COMMISSION ACTION FORM

REQUEST: REZONING AND MAJOR SITE DEVELOPMENT PLAN FOR 125 AND 130 WILDER AVENUE

OVERALL SITE GRADING PLAN
SUNSET RIDGE TOWNHOMES
7TH ADDITION
AMES, IA

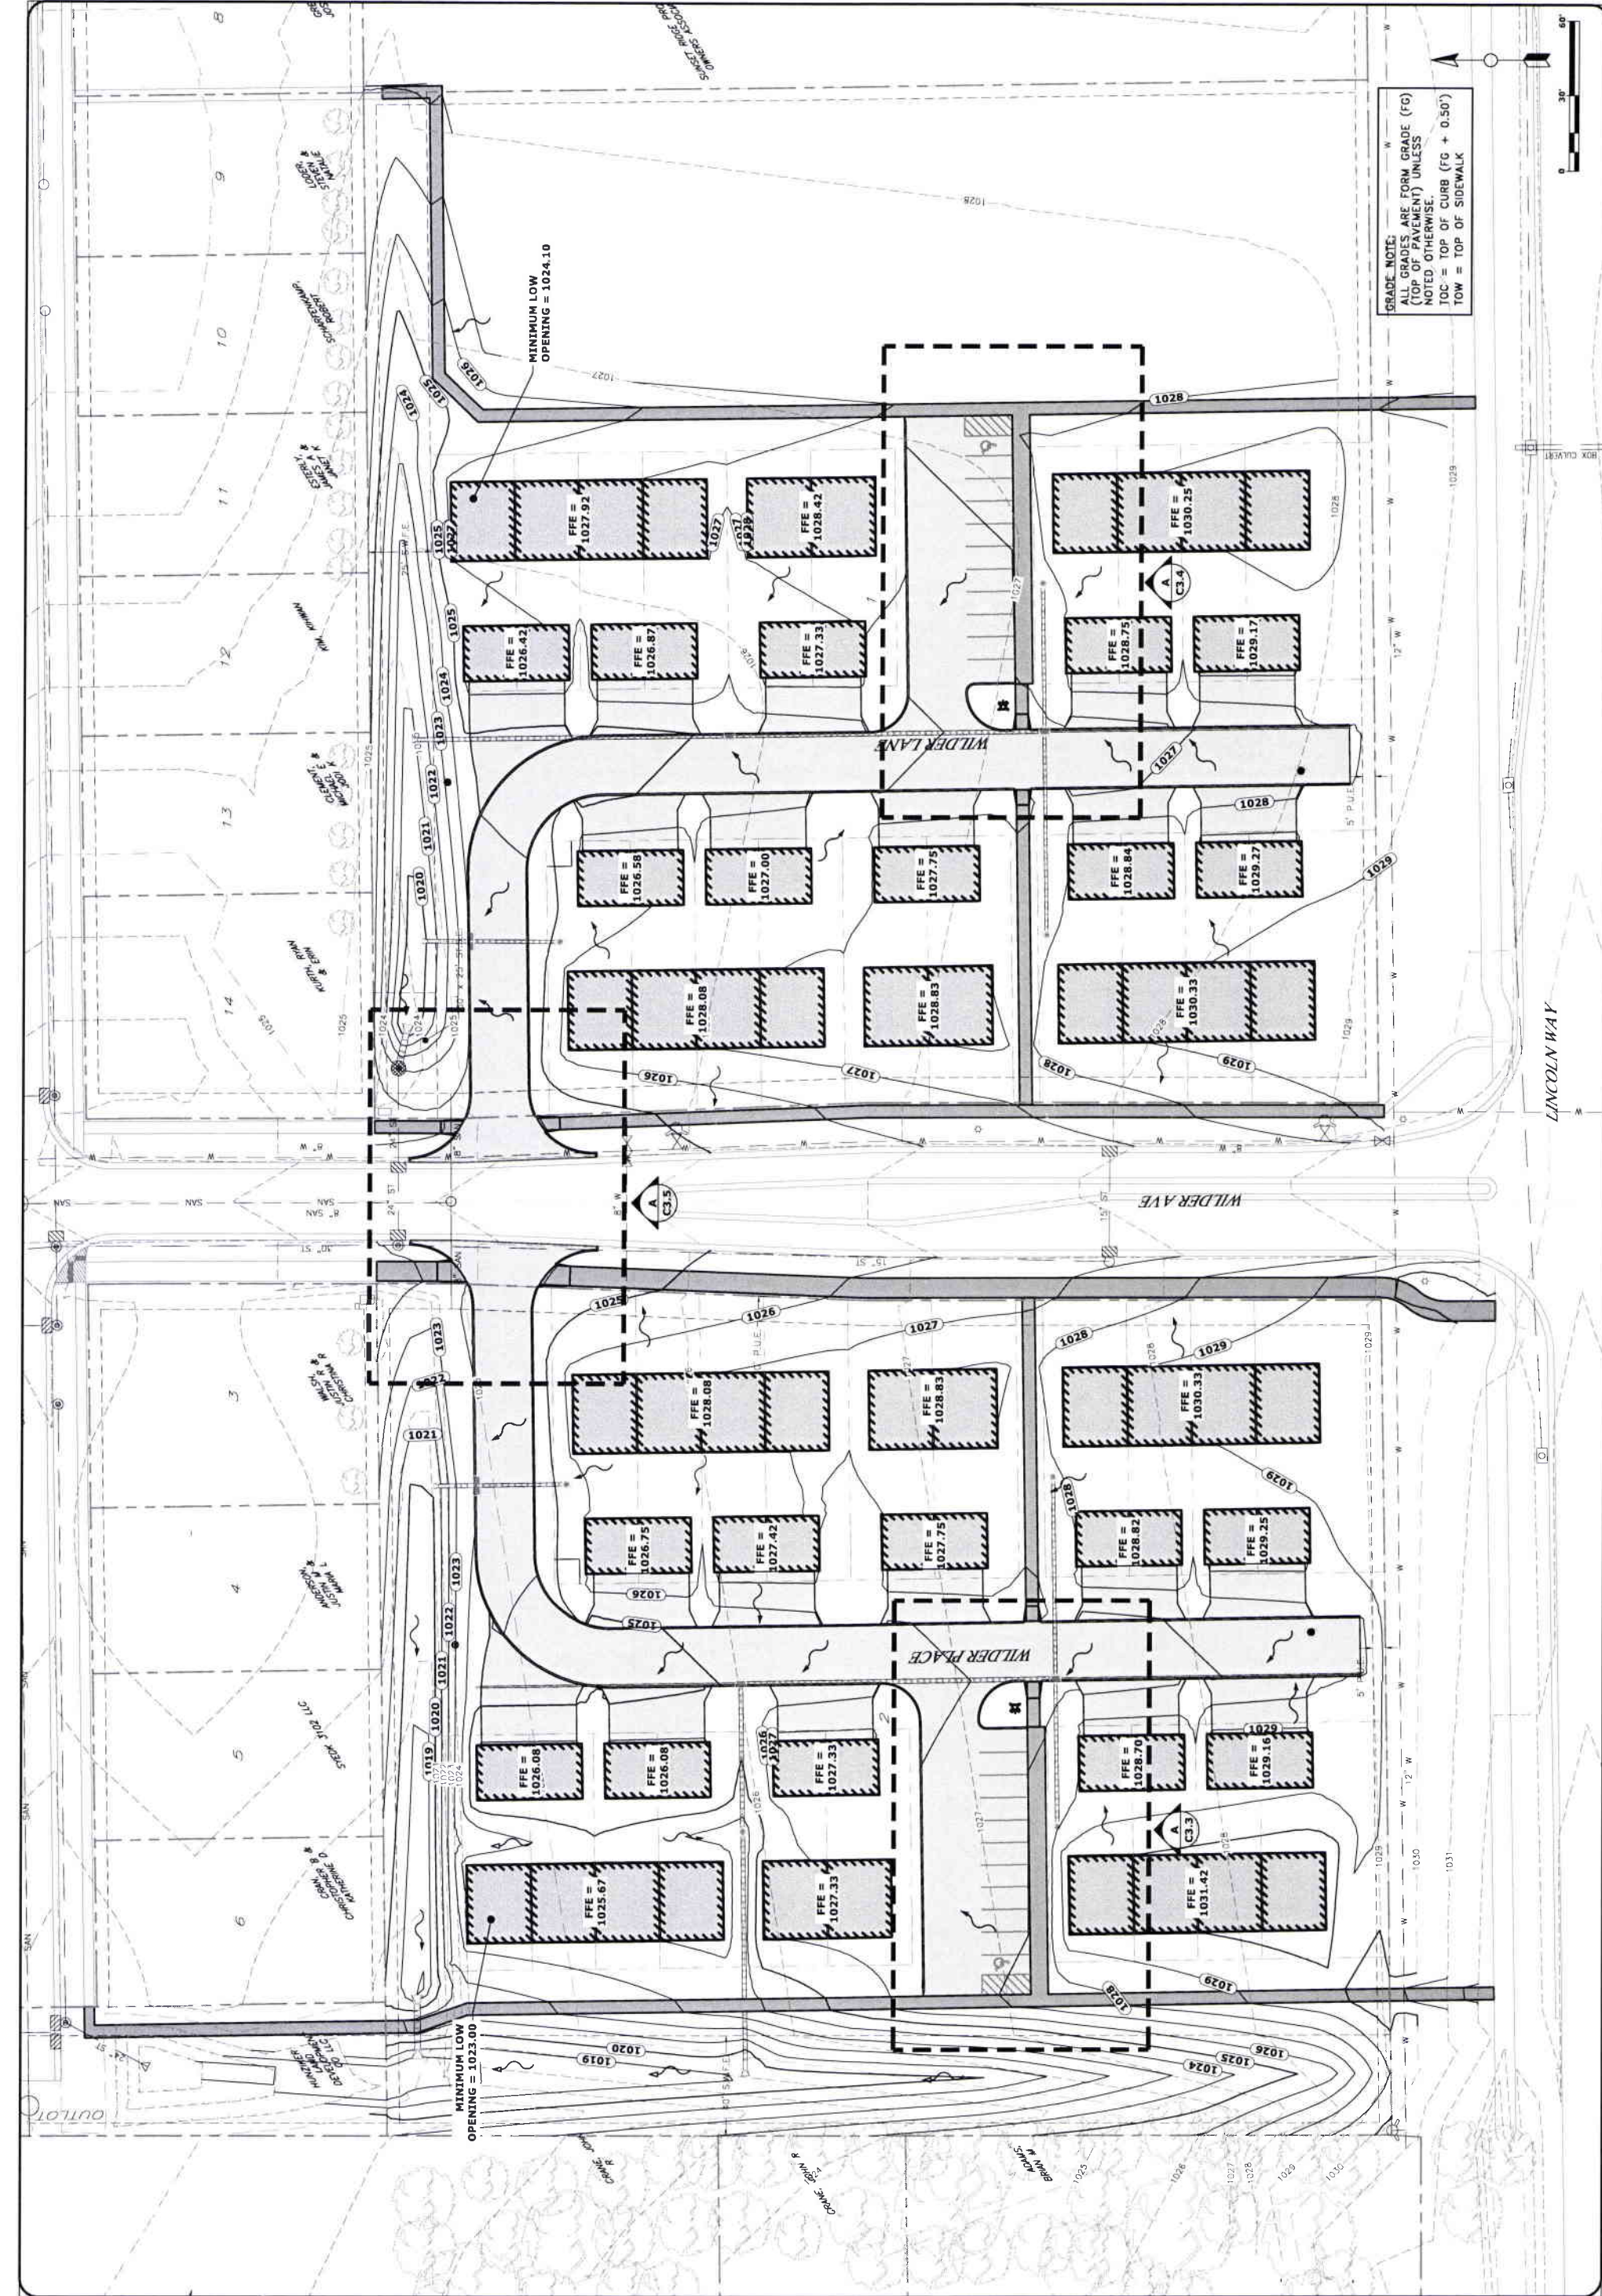
- ii. Revision of the landscape plan to include the clustering of additional shrubs along the north property lines to meet the intent of the L3 screen buffer for the PRD.

of Wilder Avenue. Buffering is proposed through the use of landscaping along the north side of the townhome development to help screen areas of the private street from the rear yards of the neighboring single family homes. The submitted plan indicates the trees required for the buffer but is very lacking in the amount of shrubs indicated on the plan from the minimum intended for this type of buffer. Staff would suggest a revision of the landscape plan to include the clustering of additional shrubs along the north property lines to meet the intent of the L3 screen buffer for the PRD.

Front Elevation

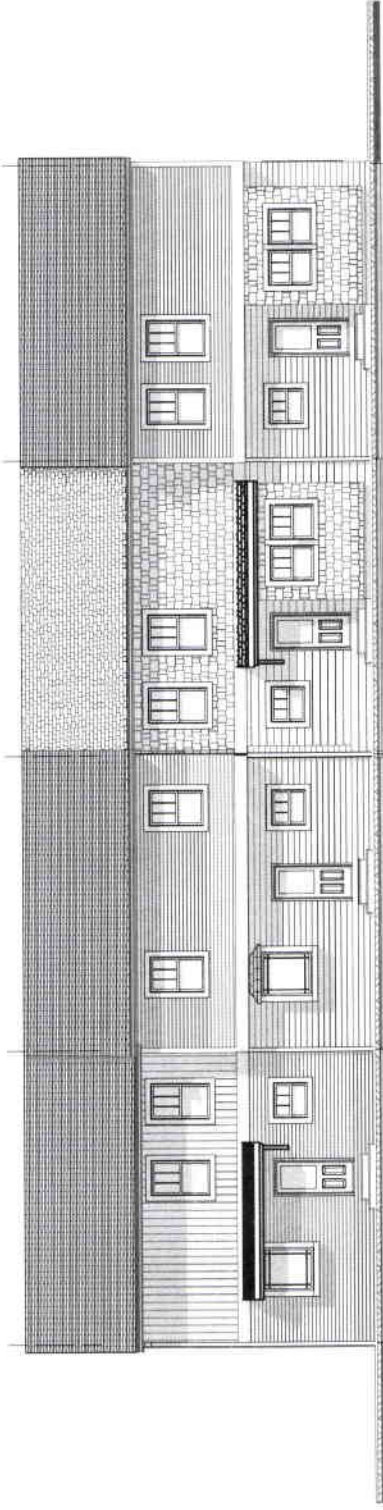
- iii. Add a stone or brick treatment to the foundation of the front façade of each building (approximately 150 square feet per unit).
 - iv. Add a front porch that extends across half of the front façade of one townhome unit for each building (total of 12 units).

The architectural design promotes unit identity and orientation to public spaces. This is a positive design approach that typically supports a walkable environment that relates to its surroundings and does isolate individual homes. The Plan provides parking spaces that exceed the minimum requirement of the zoning code. The overall organization and layout of the site is oriented to the address potential concerns of the surrounding neighborhood, with further development of the landscape buffer, and accommodates the required common open space requirements of the PRD. The connection to the existing sidewalk and trail system helps to incorporate this style of residential development with the existing single family homes of Sunset Ridge subdivision. As entry level housing, the project attempts to use common building materials to fulfill the desired character for the homes. It principles relies upon vinyl siding and some basic architectural features of covered entries and slight modulation in the roof line. Staff believes that adding a base material to the foundation will help to add character to the homes style.
